TO: Sue Mueller
FROM: Rick Dorris 
DATE: July 27, 2007
SUBJECT: Ridges Mesa TEDS Exception Request

Re: *Design Exception #15-07, Ridges Mesa PD PP-2006-358*

DESIGN EXCEPTION REQUEST 15-07

Project: Ridges Mesa PD - Preliminary Development Plan

STREET LIGHTING PER TEDS MANUAL

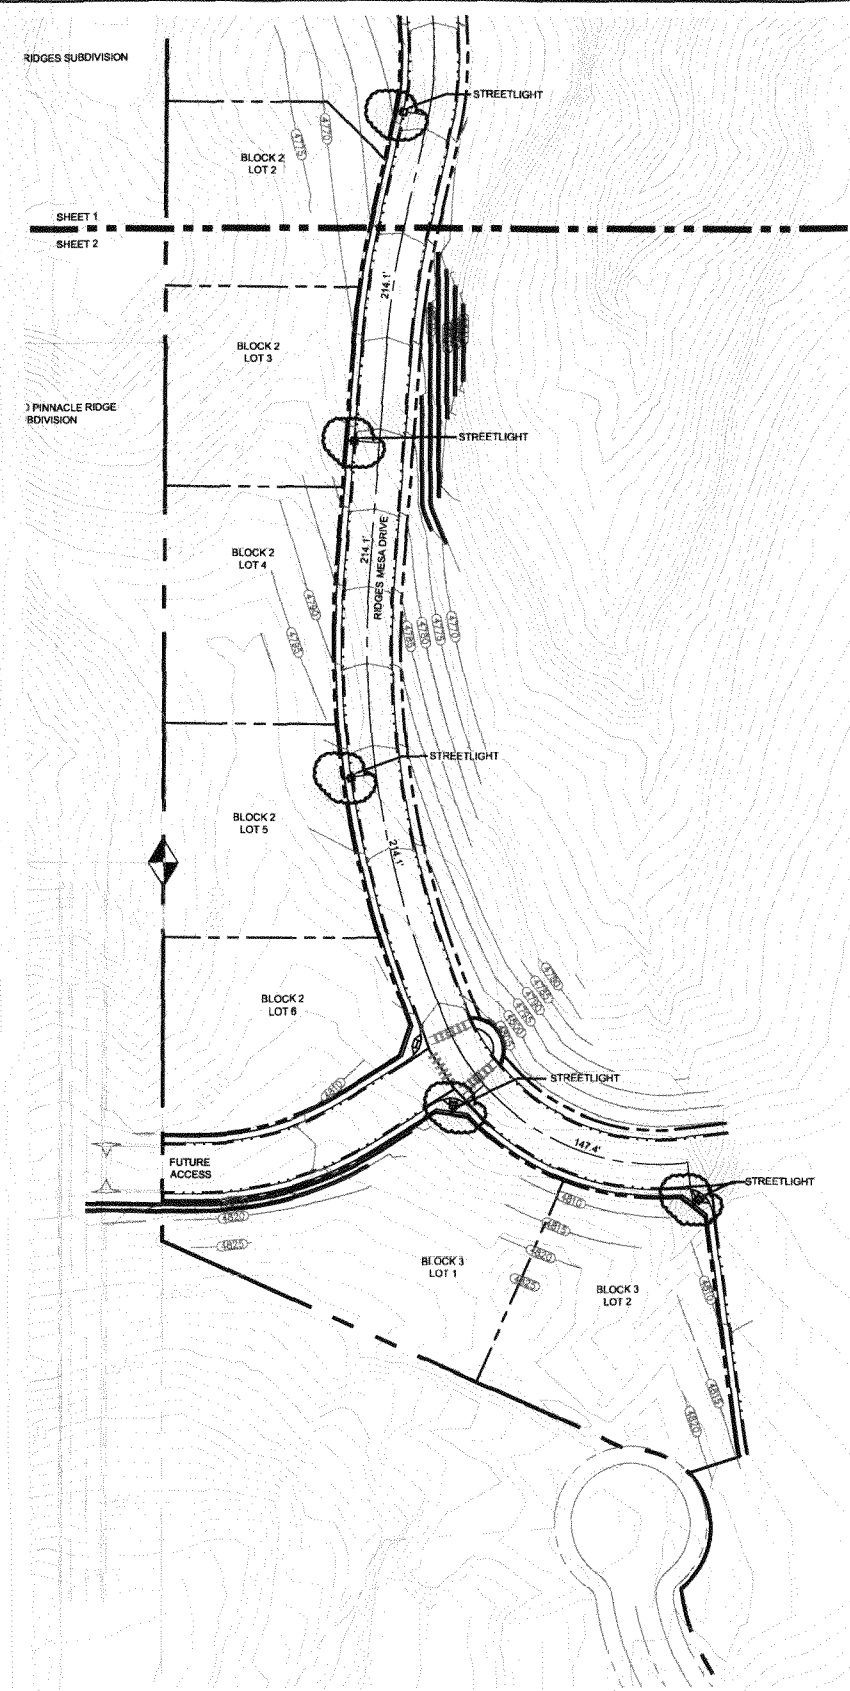
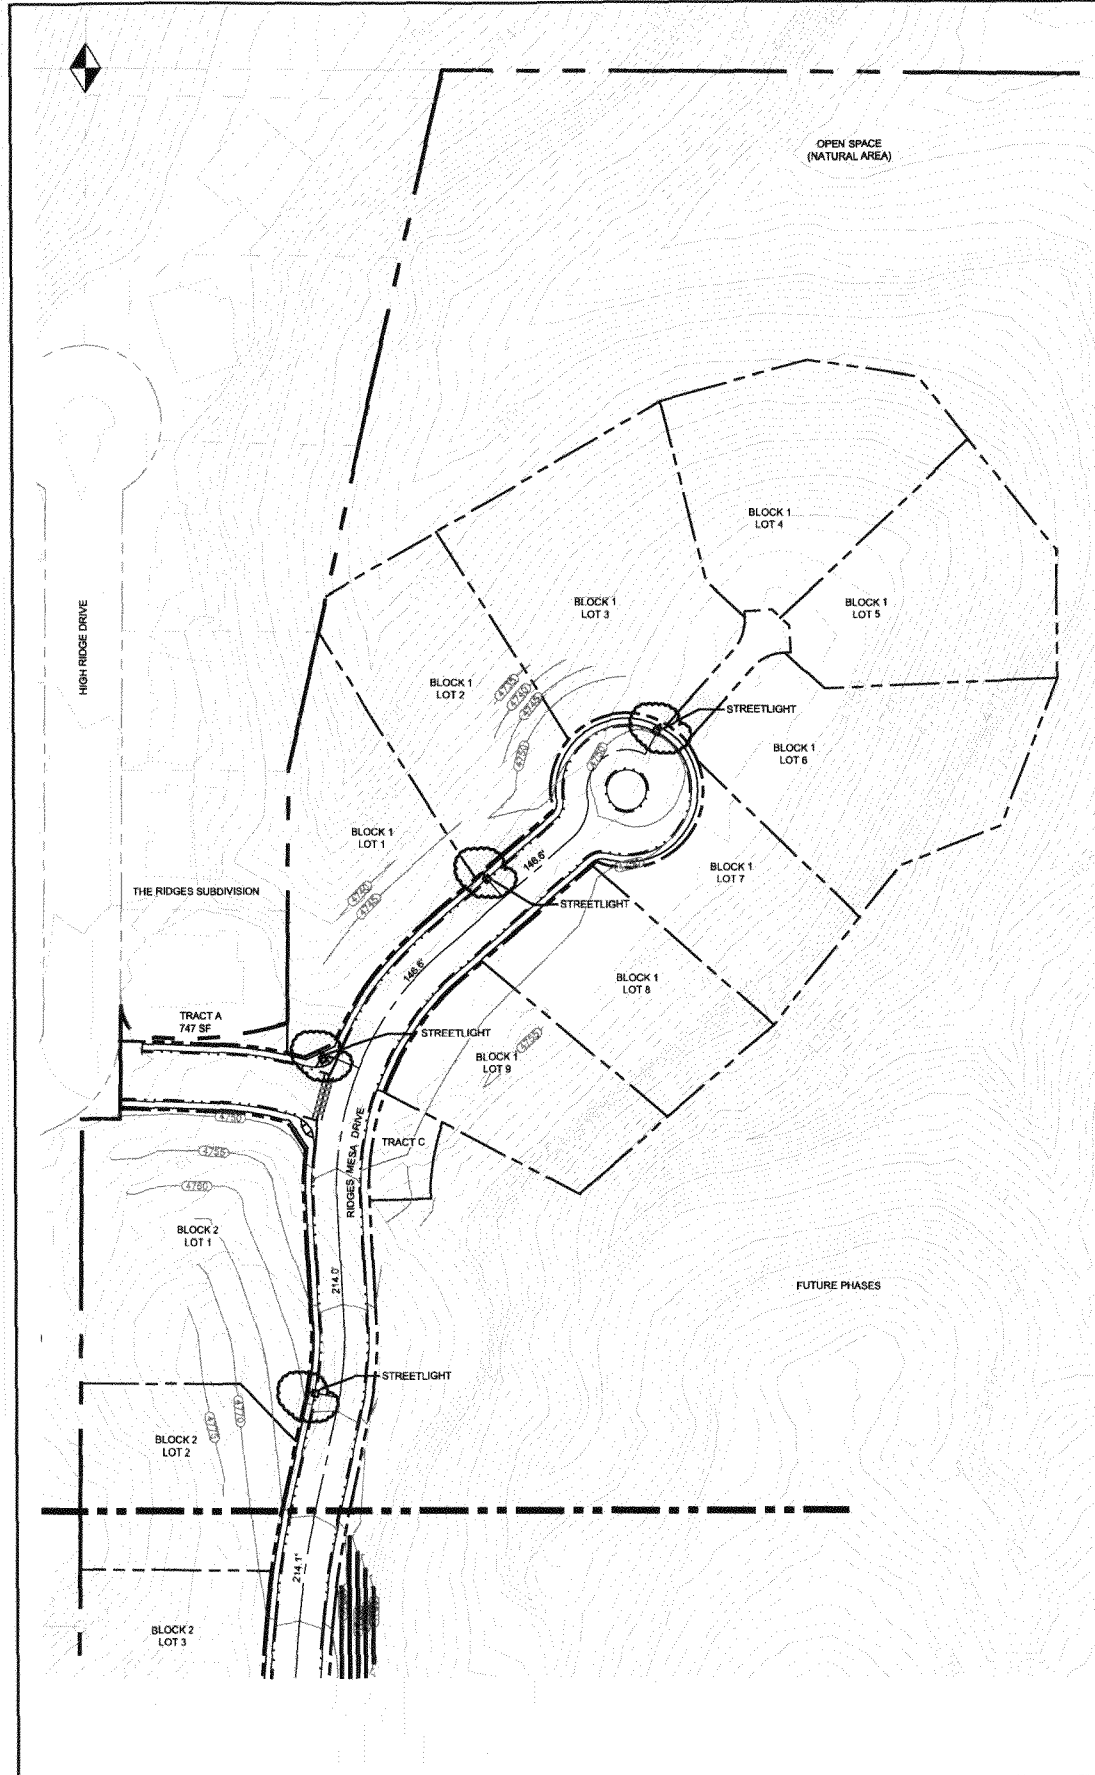
As shown on the attached drawing, application of this standard requires the placement of eight streetlights. The applicant is requesting an exception to place streetlights only at the existing intersection of the proposed Ridges Mesa Drive with Hidden Valley Drive and the intersection of the proposed Ridges Mesa Drive and the proposed Pinnacle Drive (from the proposed Pinnacle Ridge Subdivision).

As shown on the attached drawings, TEDS requirements can be met with eight streetlights. Alternatives exist to provide 3, 4, 5, 6 or 7 lights as well but are not shown graphically. No other alternative exists that would meet this standard.

**PROPOSED
STREET LIGHTING
TEDS EXCEPTION
REQUESTED**

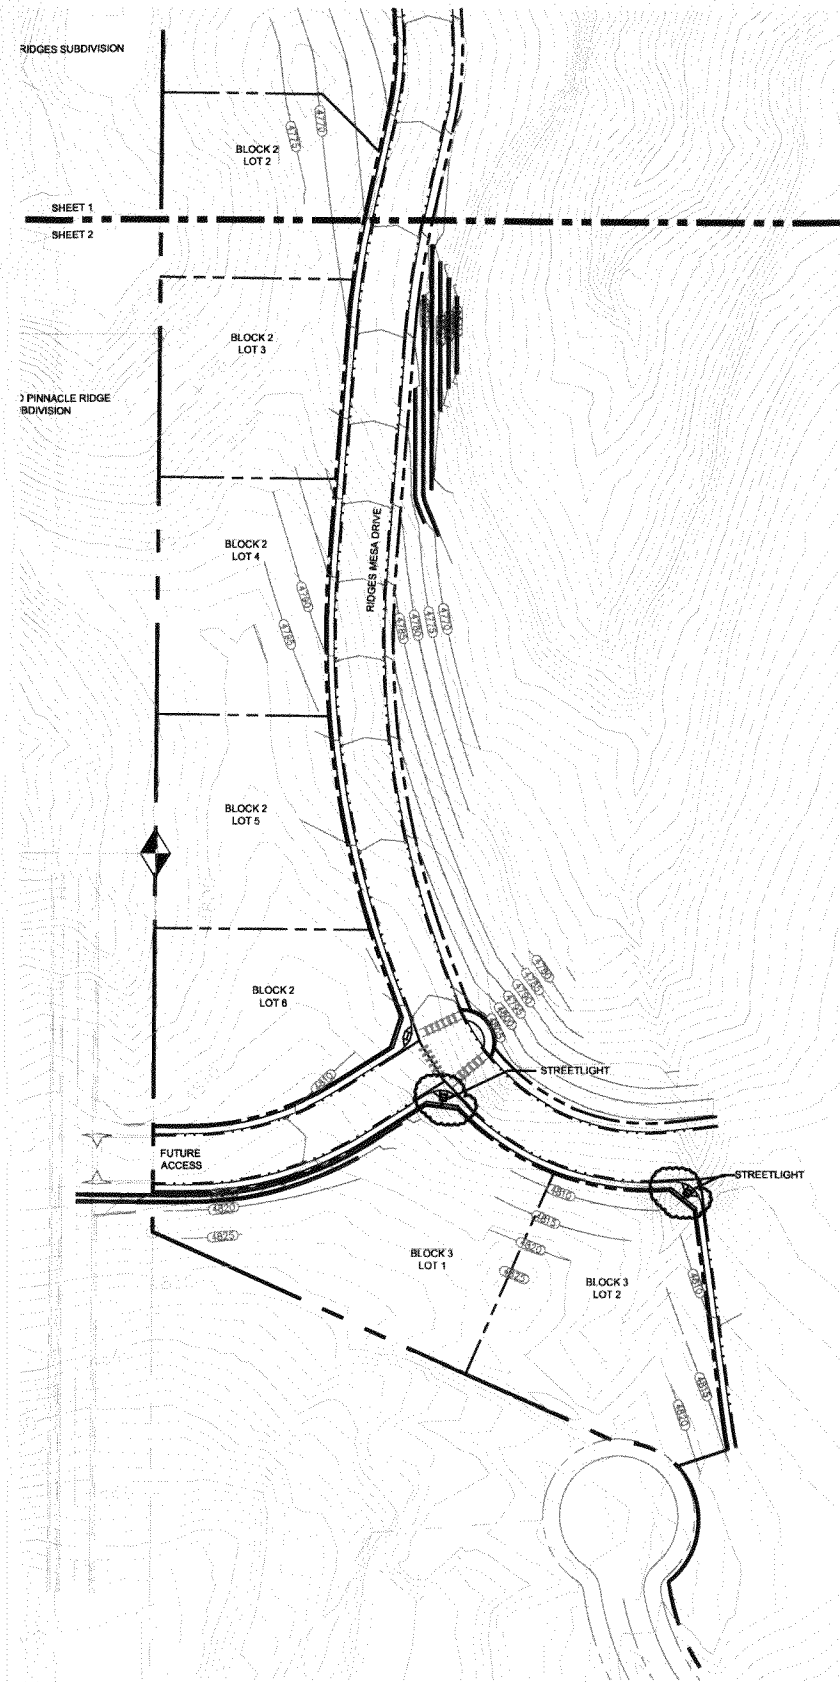
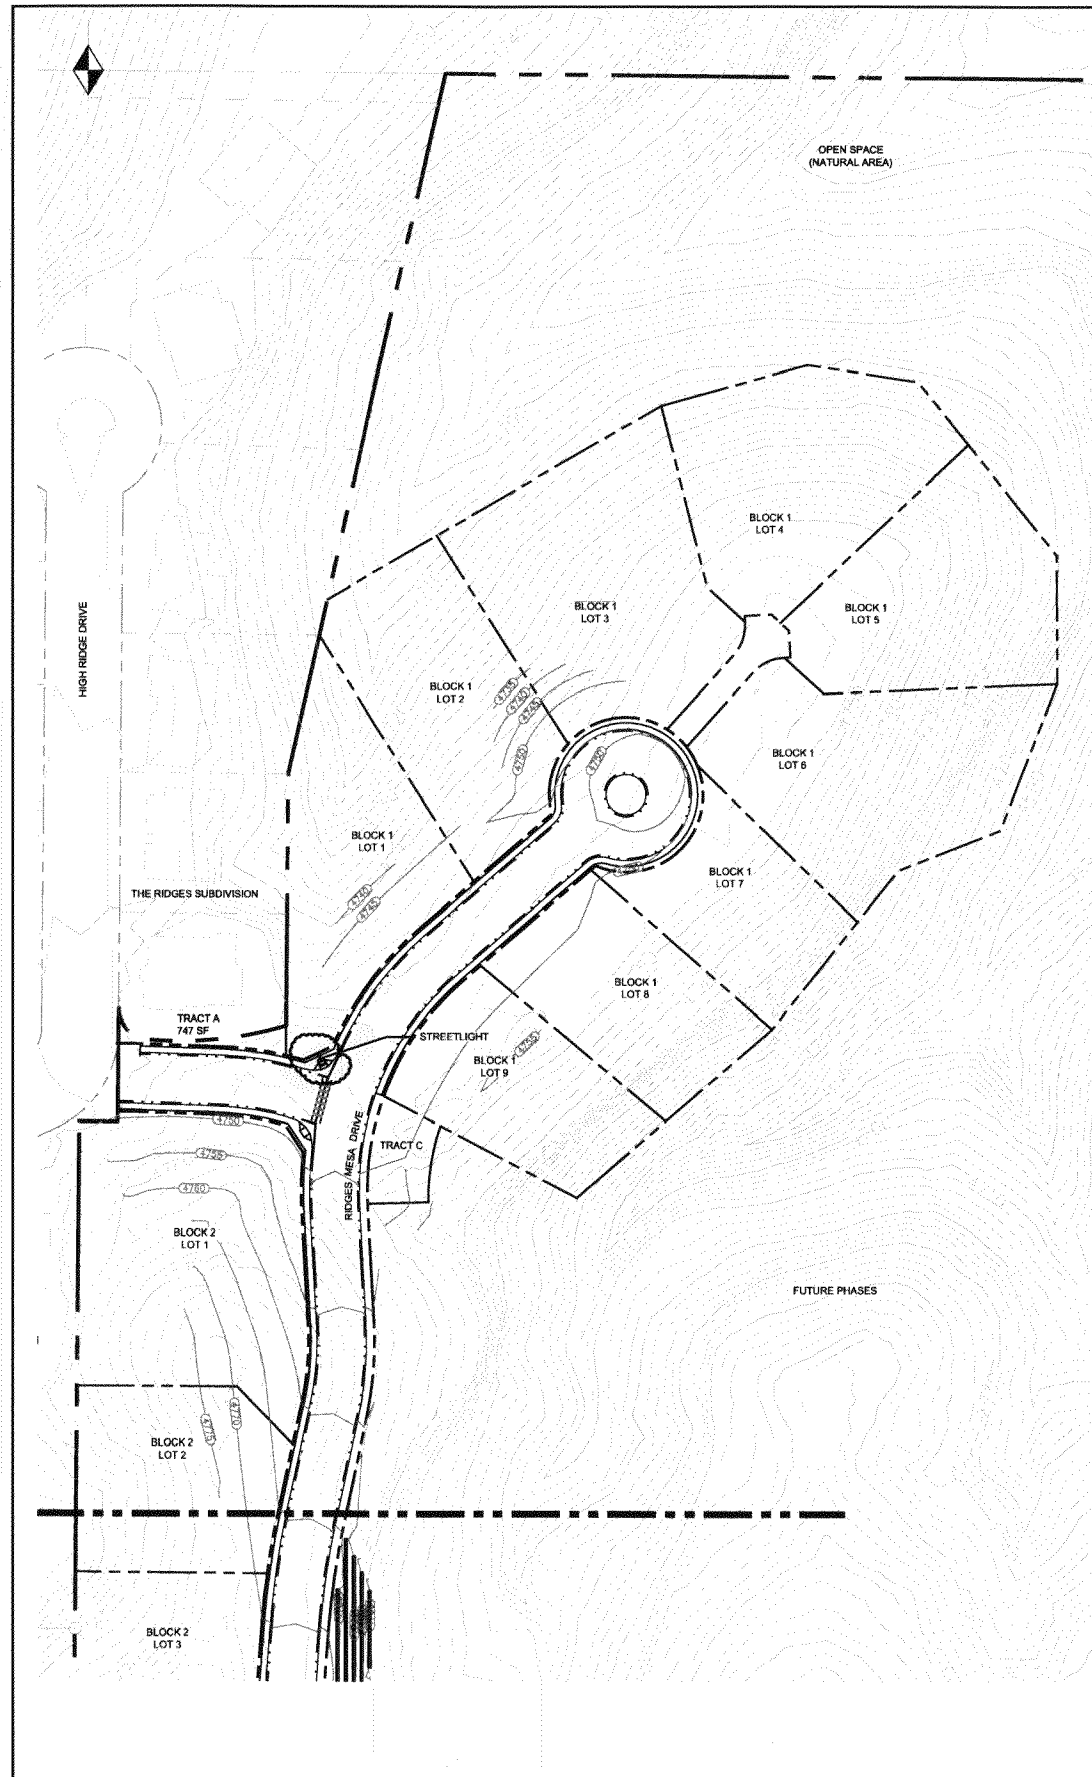
Reduce the required number of streetlights from six to two. Streetlights would be located only at street intersections.

The request to limit streetlights to the two intersections meets the intent of the plan by meeting safety needs at the area needed most – where automobiles, bicycles and pedestrians come together at street intersections. By limiting the number of lights, trespass of light onto individual lots will also be minimized.

Approved as Modified: ADD STREET LIGHT AT END OF CUL DE SAC. AND ALL INTERSECTIONS.
